## UNITED STATES PATENT AND TRADEMARK OFFICE

APPLICATION NO.	FILING DATE	FIRST NAMED INVENTOR	ATTORNEY DOCKET NO.	CONFIRMATION NO.
10/576,923	02/26/2007	Eugenio Longo	D-43685-01-US	9118
7590		06/01/2010	EXAMINER	
Thomas C. Lagaly Law Department Cryovac, Inc. Post Office Box 464 Duncan, SC 29334			HYLTON, ROBIN ANNETTE	
			ART UNIT	PAPER NUMBER
			3781	
			MAIL DATE	
			06/01/2010	
			DELIVERY MODE	
			PAPER

<b>Office Action Summary</b>	<b>Application No.</b> 10/576,923	<b>Applicant(s)</b> LONGO ET AL.
	<b>Examiner</b> ROBIN HYLTON	<b>Art Unit</b> 3781

Fig. 1

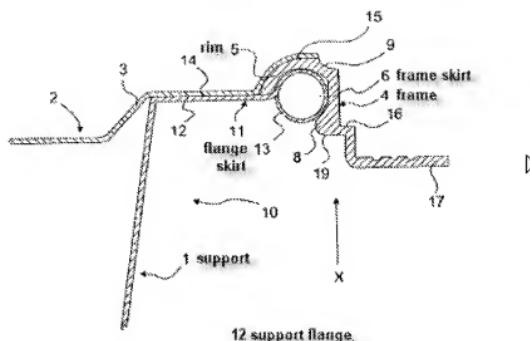
6. Claims 1-4 are rejected under 35 U.S.C. 102(b) as being anticipated by Cornelisse et al. (EP 1,127,809).

The central area of the support (1) and a portion of the flange (12) are not covered by the rim (5) of the frame.
